CERTIFICATE OF APPROPRIATENESS

Property: 805 Franklin Street, Lots 3, 4, & 5, Block 16, SSBB Subdivision. The property is a vacant lot situated on a 15,002 square foot (150' x 100') corner lot.

Proposal: New Construction – *This project was deferred at the July 2016 HAHC meeting so that the applicant could further work with staff.*

Recommendation: Deferral – The applicant has requested a second deferral of this project.

SOUTH ELEVATION –FACING FRANKLIN STREET

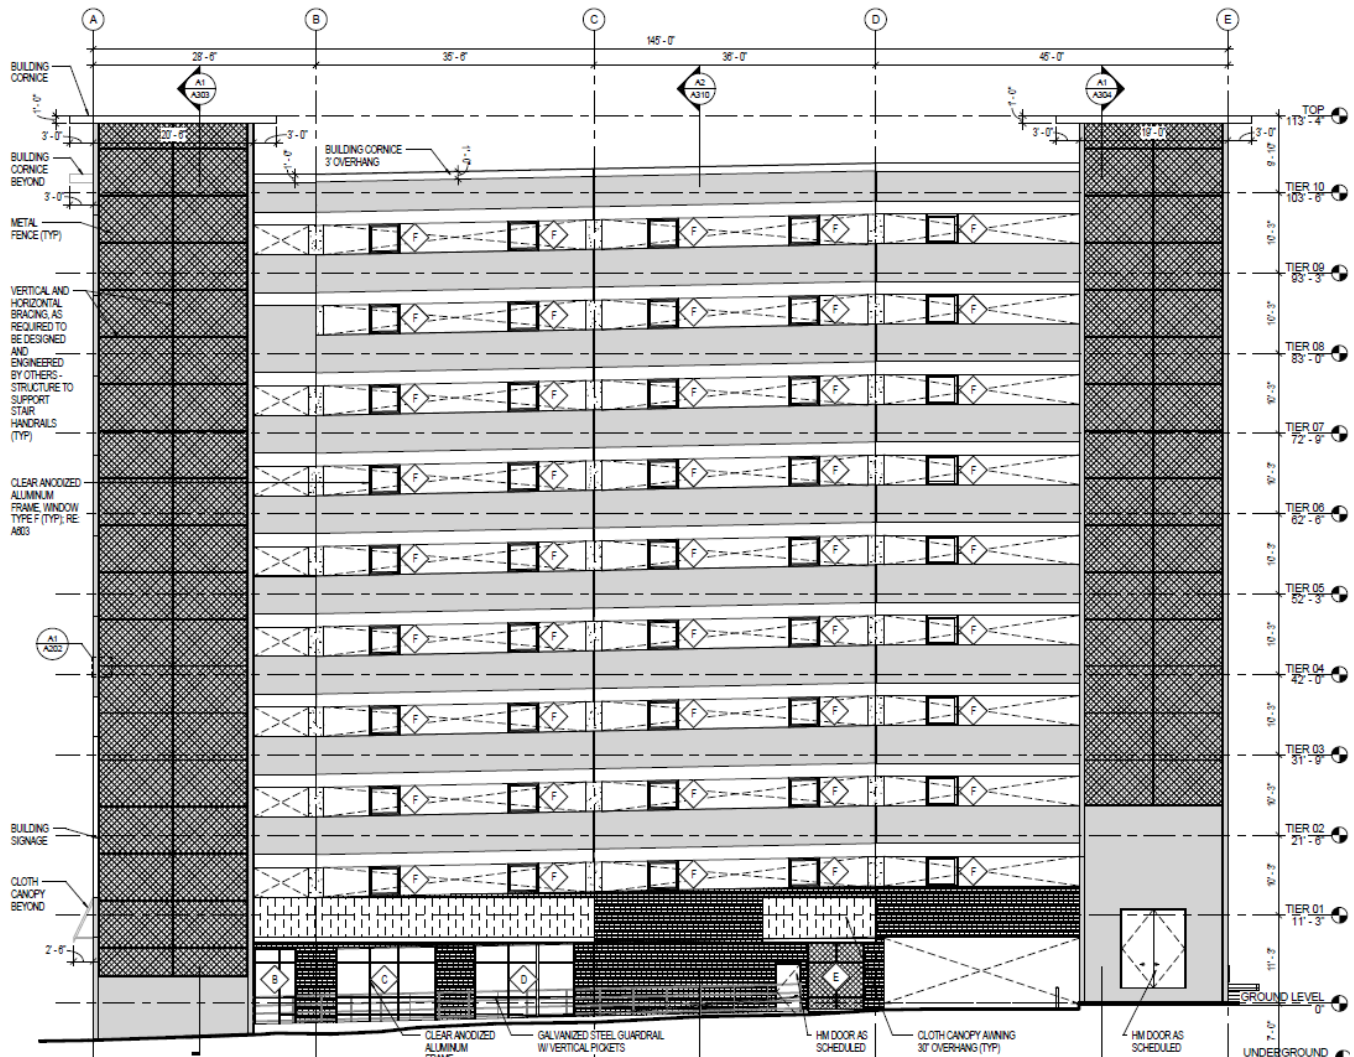
The applicant and staff have diligently worked together in order to design a compatible structure that compliments the existing historic buildings in the district. However, at this point, the exterior features of the proposed structure are not fully compatible with the exterior features of other contributing structures in the context area.

The main issues of the project involve the horizontal nature of the structure as well as the street level detailing. Satisfying criteria can be accomplished by incorporating more vertical elements to better match vertical elements, such as window openings, that are typically found within the district. Although this can be partially seen on the Milam elevation with the inclusion of vertical aluminum window frames; the square frames and overall horizontal nature along the Franklin side is uncharacteristic of the district. At the ground level, suspended awnings as opposed to cloth awnings should be installed above the storefronts. This type of awning is more typically seen throughout the district, and is more historically appropriate. The use of additional brick veneer and perhaps some form of curtain wall may also make the structure more compatible with the Main Street Market Square Historic District.

Staff would also be in support of a more contemporary design that is able to incorporate the massing and components of other historic buildings within the district. Historically, the taller structures within the district feature a distinct base, a rhythmic series of vertically oriented bays, and a prominent cornice. The system of base, bays, and cornice should be replicated in the proposed design. On the ground level, the incorporation of a false store front system (complete with delineated knee walls and transoms) and topped by deep overhanging suspended awnings will help identify the pedestrian focused nature along the street level. The use of vertical screens and panels installed at spaced intervals along the two street facing elevations will emulate the historic rhythm of bays while still maintaining the openness required of a garage. The structure should then be capped with a cornice to complete the traditional three part design of a historic building. The overall design does not have to be ornate or over decorative, and in fact, should be simple and more refined. By featuring the components, as extracted features, of traditional buildings, the structure will blend in and act as a benign backdrop to the surrounding buildings.

EXAMPLES OF VERTICAL PANELS

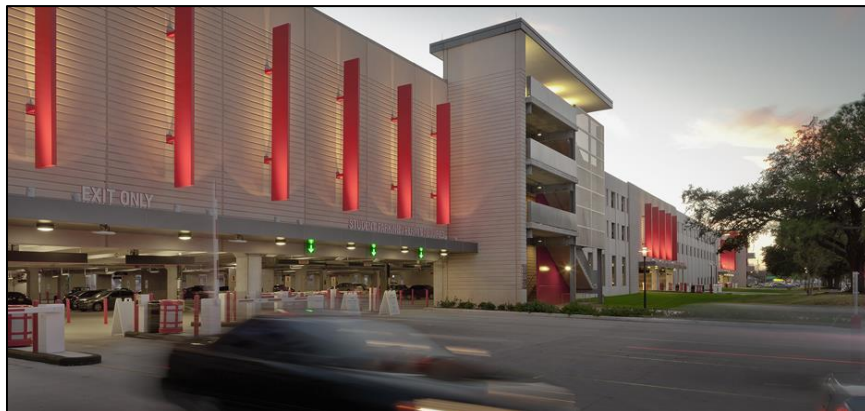
The use of repeated vertical panels can be used to help break up the façade as well as give the horizontally designed structure a more vertical feel.

This example also uses vertical panels to help break up the façade, although the large open sections showing the horizontal parking decks would be less effective in current project.

EXAMPLES OF VERTICALLY DEFINED COLUMNS AND BASE FEATURE

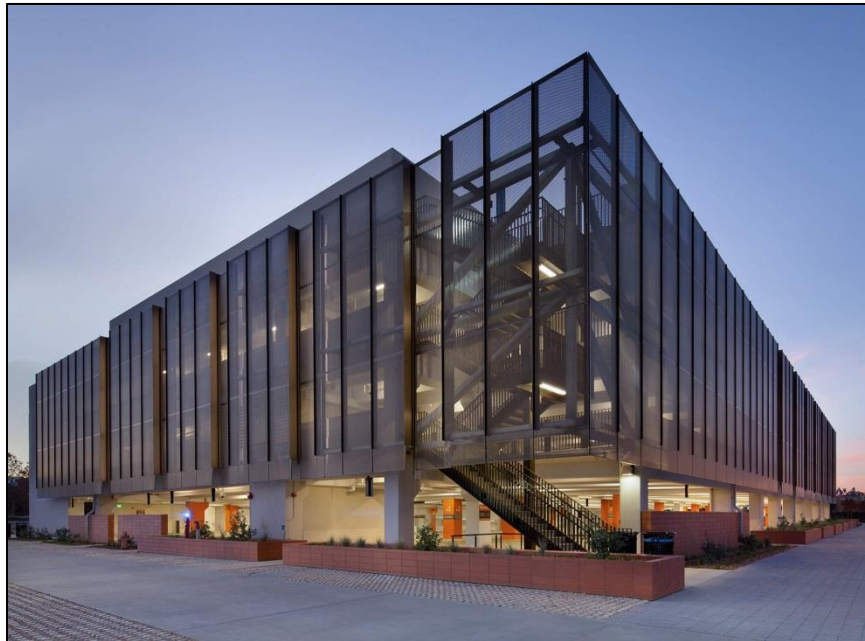
In this example, the use of more massive vertically defined columns along with a more traditional base, cornice, and use of brick, gives this structure an appropriate appearance as historic infill.

This example also features a strong delineated base, complete with storefronts and deep awnings. The more traditional design of massive brick columns in conjunction with modern vertically oriented screens makes this compatible infill as well.

EXAMPLES OF CONTEMPORARY AND TRADITIONAL MATERIAL USE

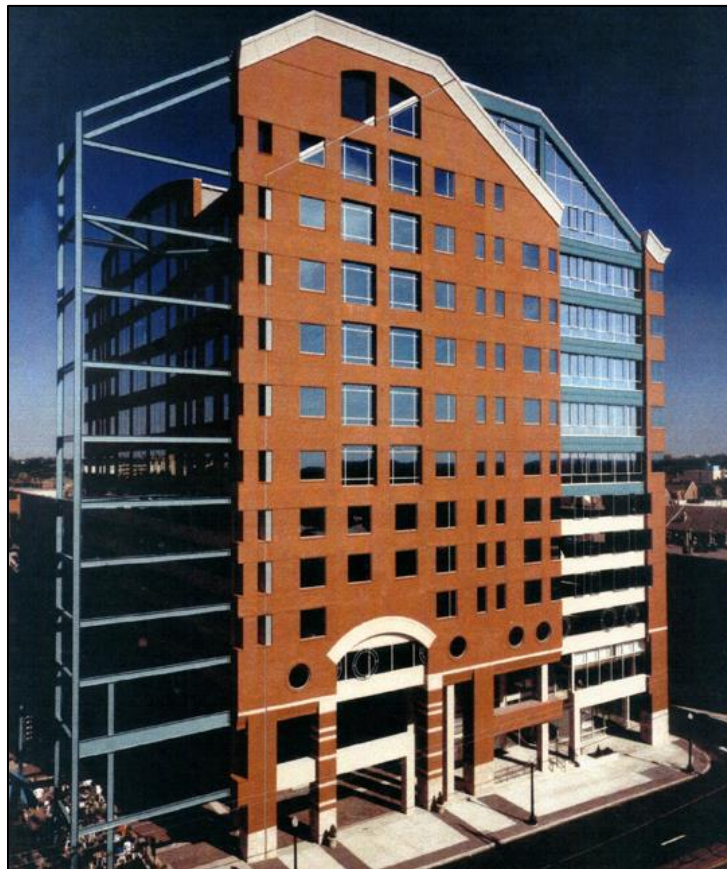
This example employs the use of traditional brick as well as metal screens. Both the brick bays and screen panels are vertically oriented. Proper infill should feature compatible elements found in the district, but may be used in a more contemporary fashion or design.

This example uses traditional brick as well as glass. Although this is a more horizontal design, the structure features vertically oriented window openings as well as deep awnings.

EXAMPLE OF CONTEMPORARY DESIGN

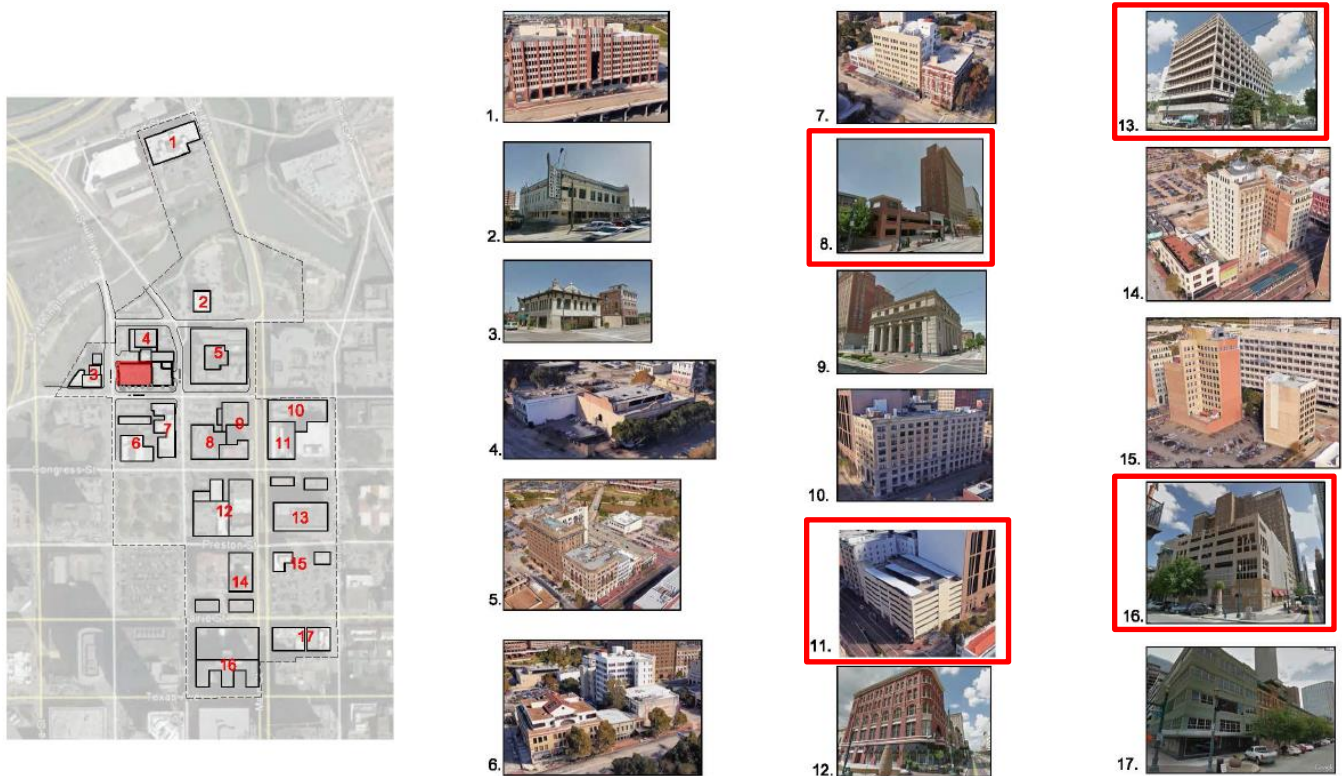
This is a very contemporary interpretation of a parking garage. Staff is not opposed to have a more contemporary design as long as it features compatible elements drawn from within the district.
